HUNTS POINT INTERSTATE ACCESS IMPROVEMENT PROJECT – CONTRACT 3

PIN X731.65, Contract D900055

Addendum #8

July 22, 2022

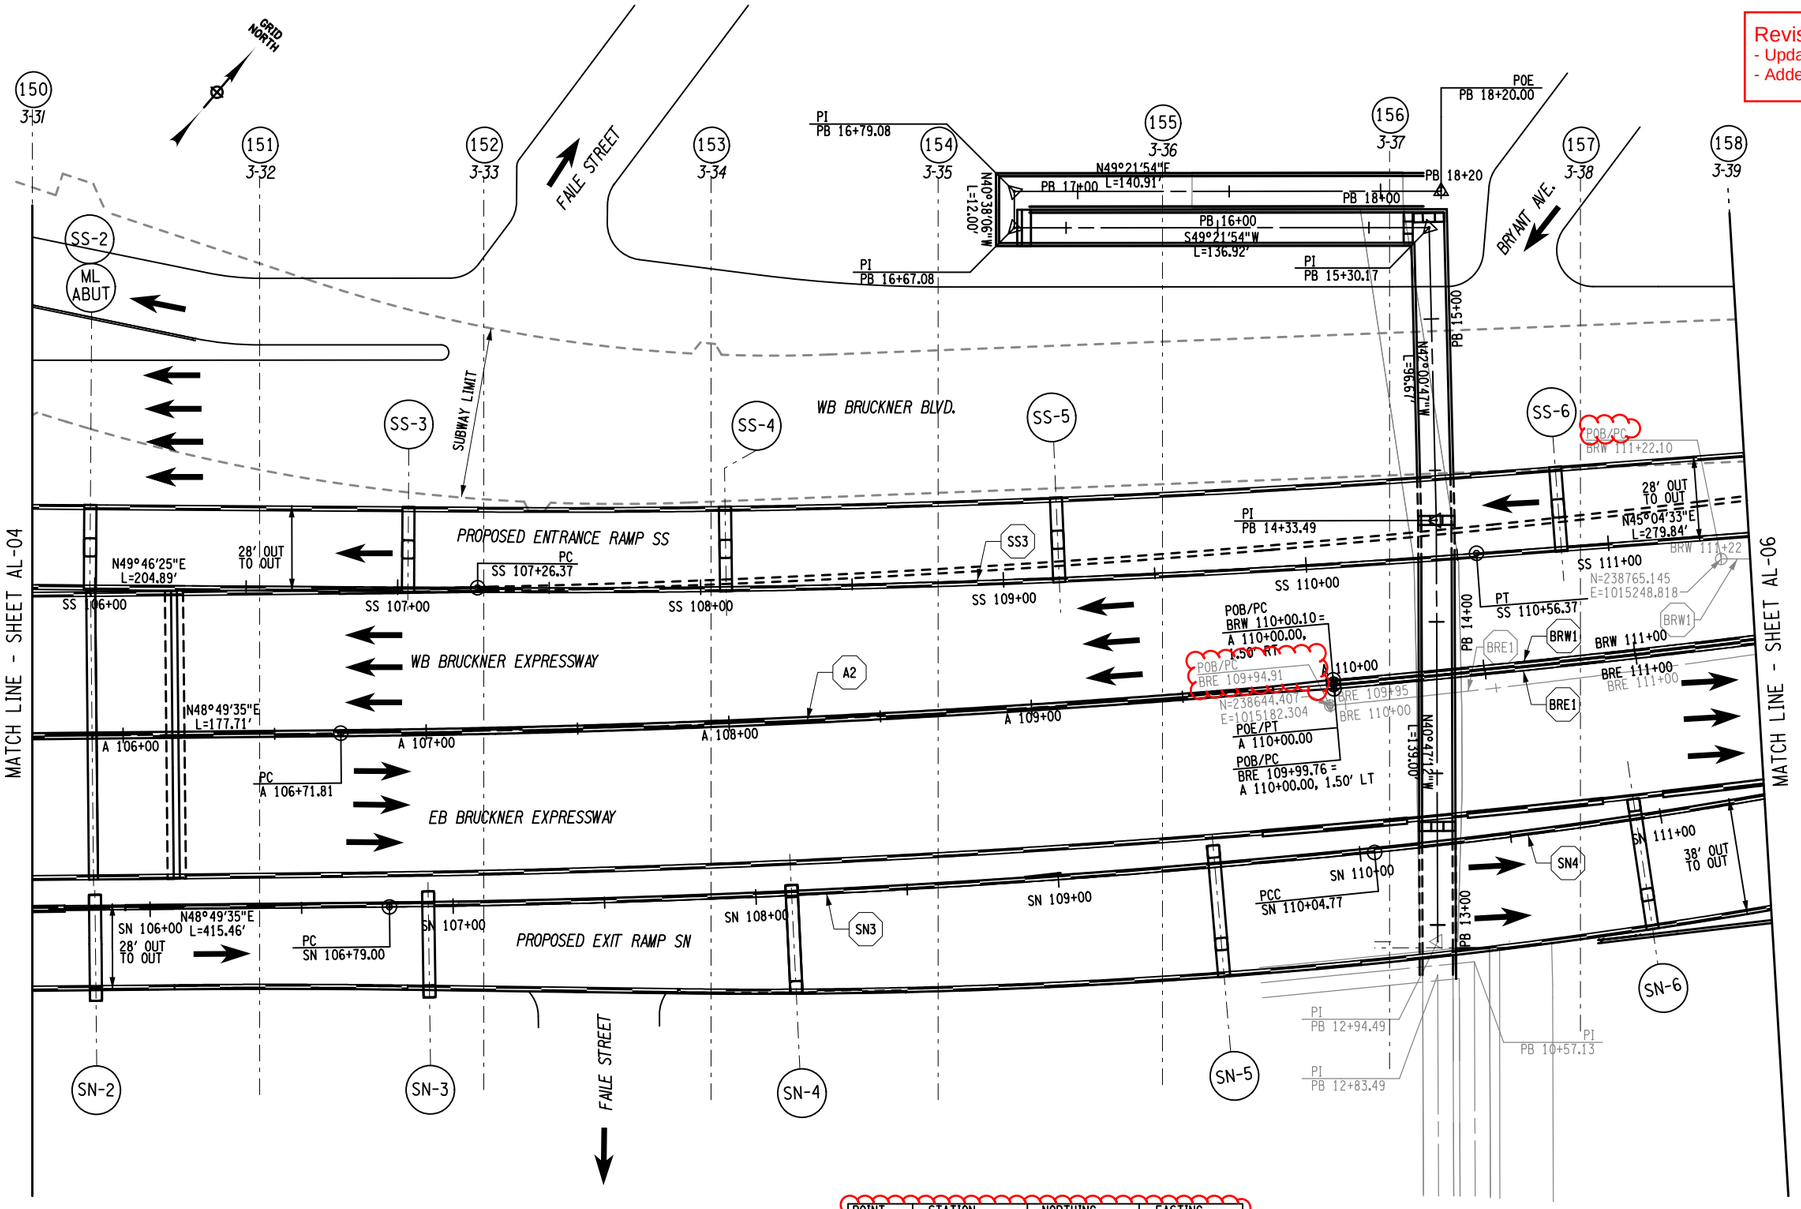
Revisions Made:
- Updated table
- Added alignment information

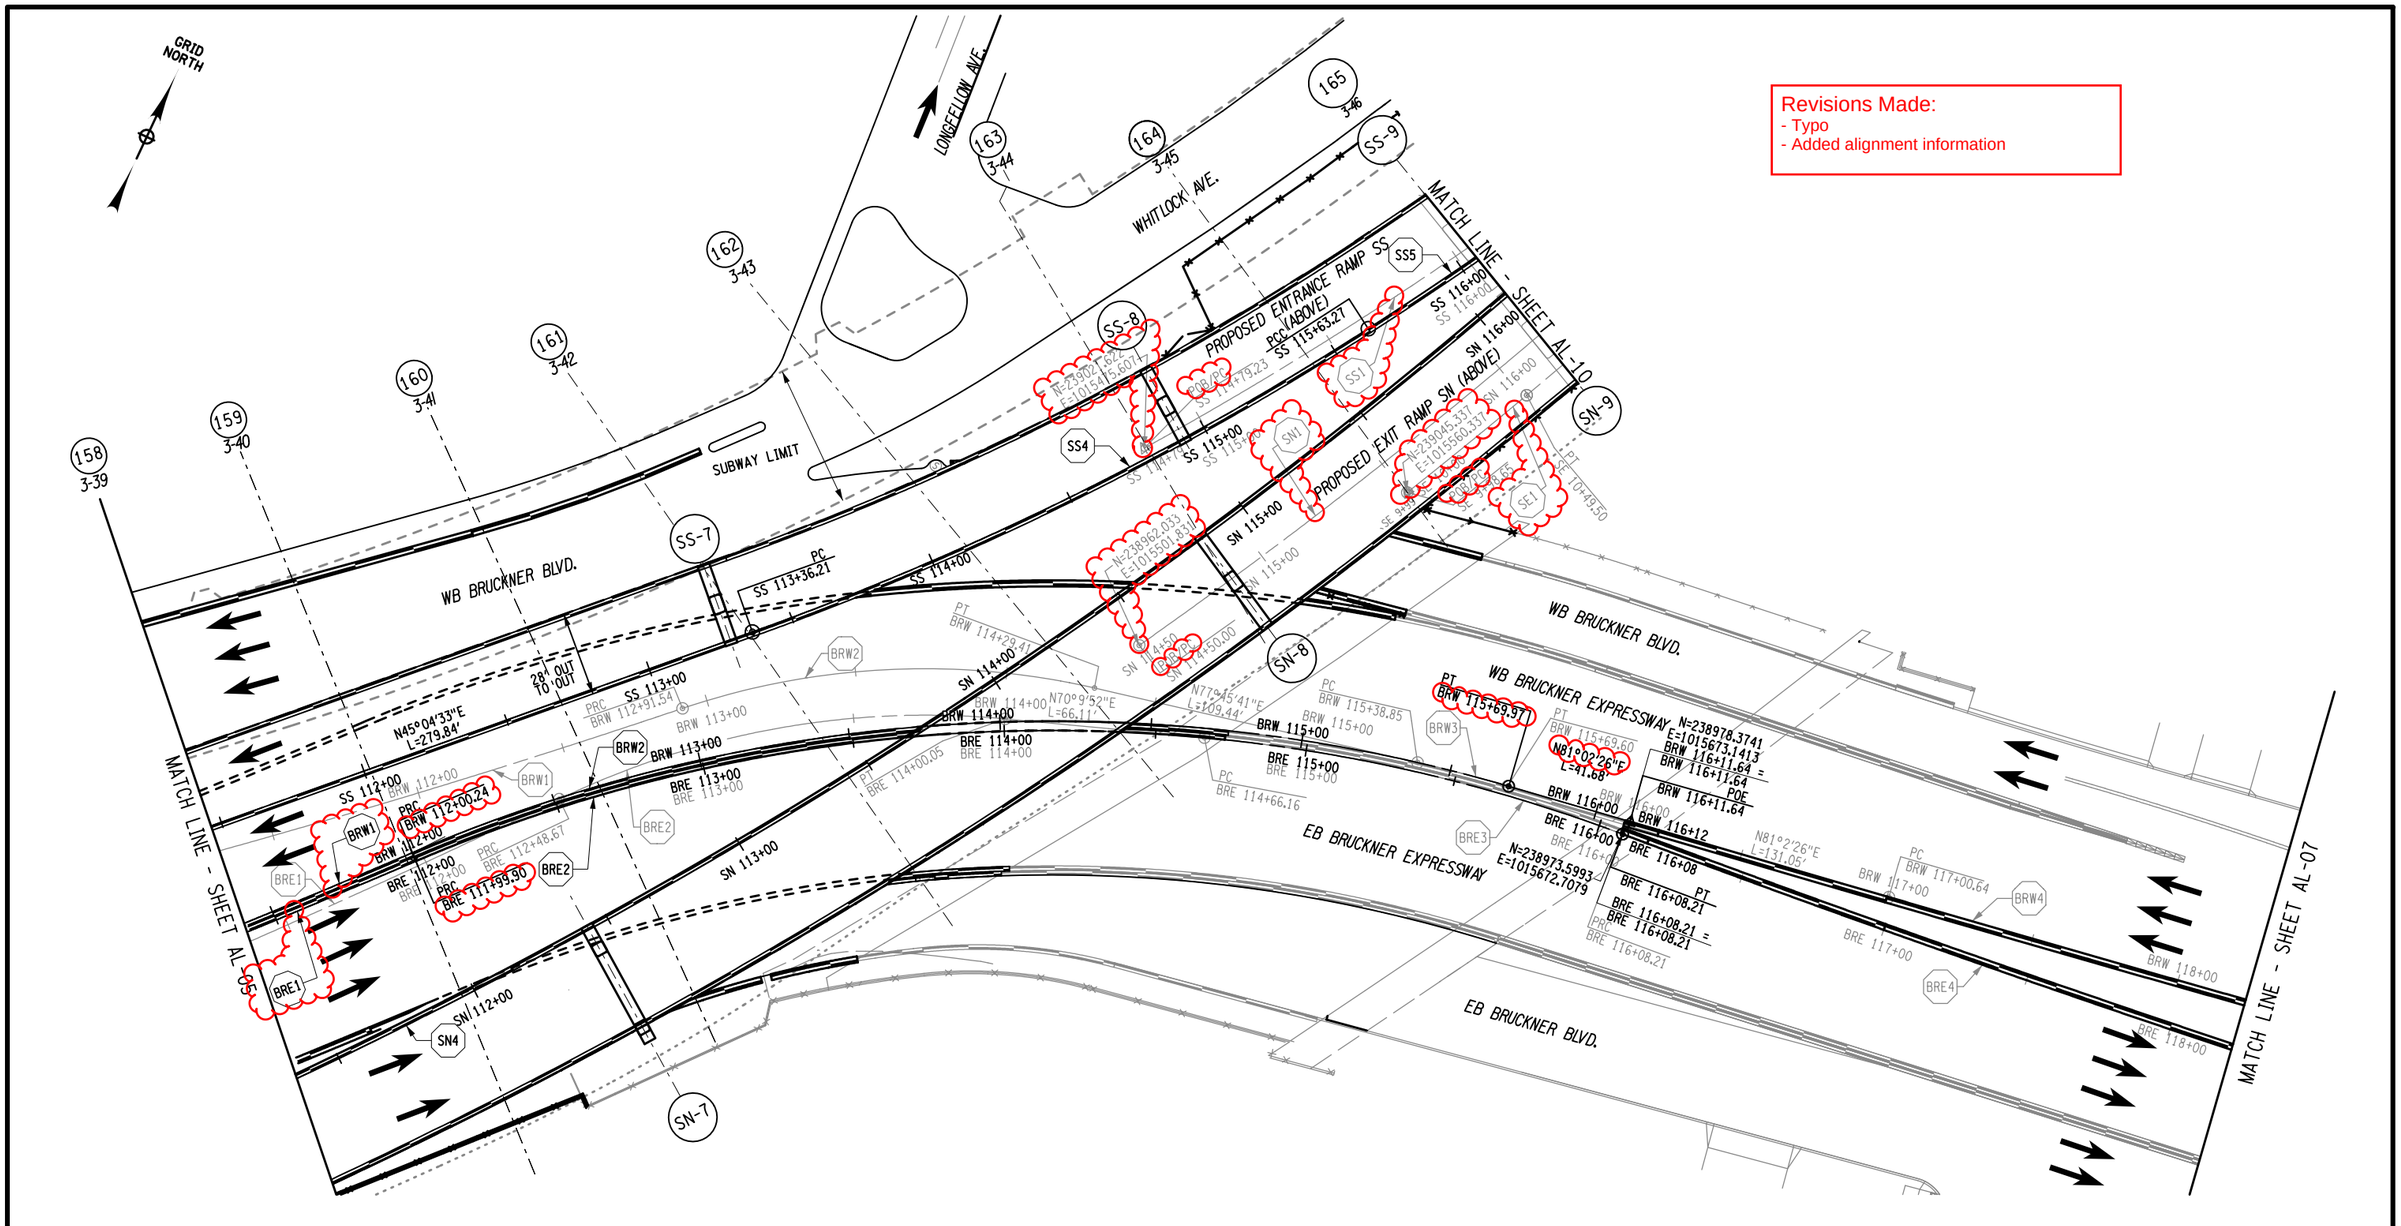
Revisions Made:
- Typo
- Added alignment information

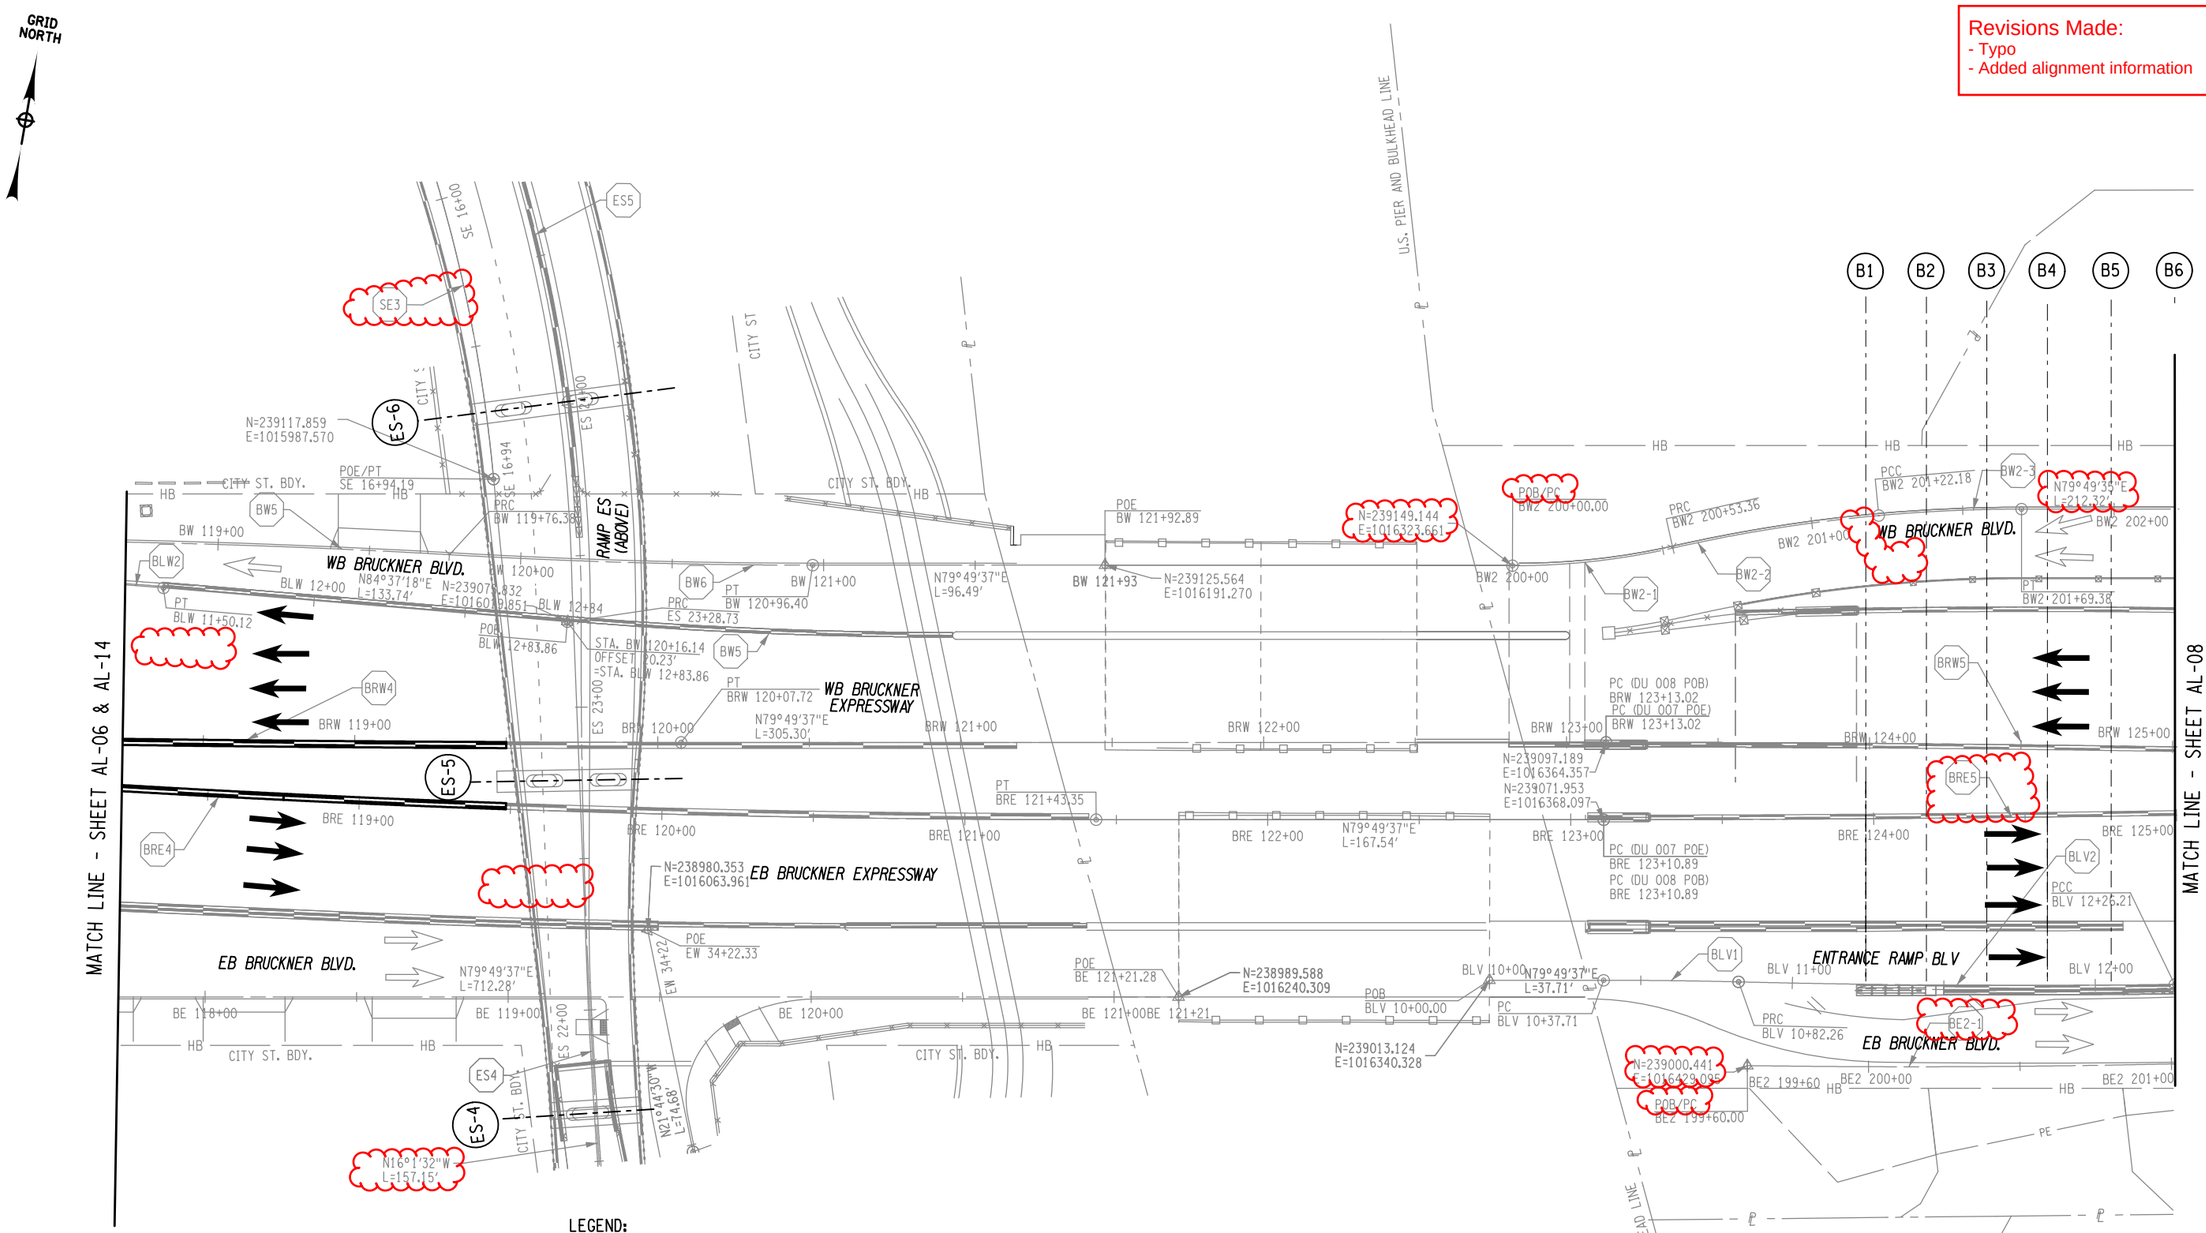
Revisions Made:
- Typo
- Added alignment information

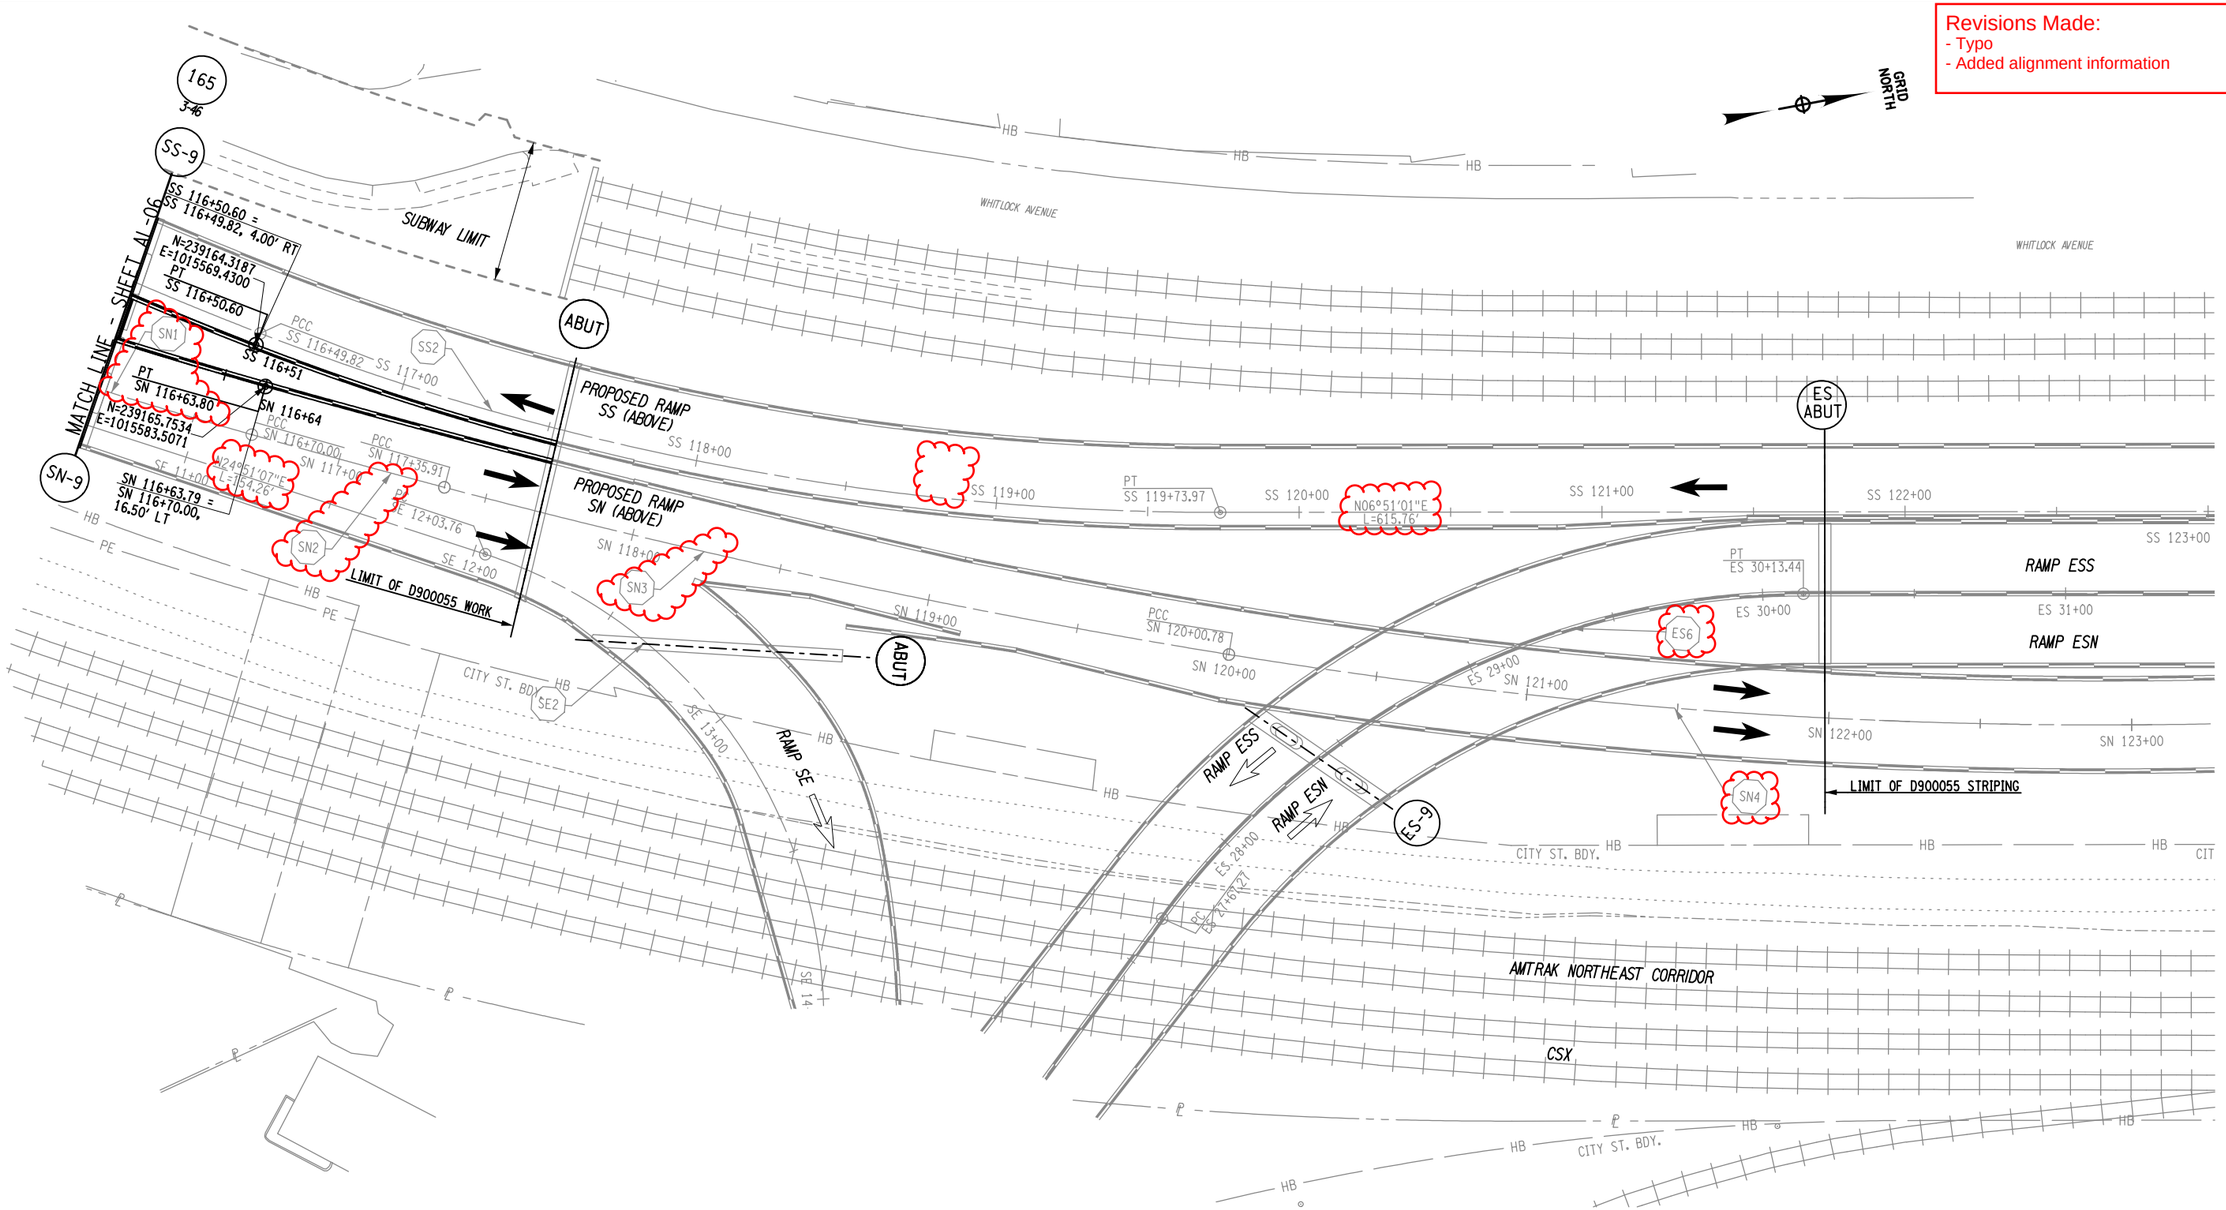
Revisions Made:
- Typo
- Added alignment information
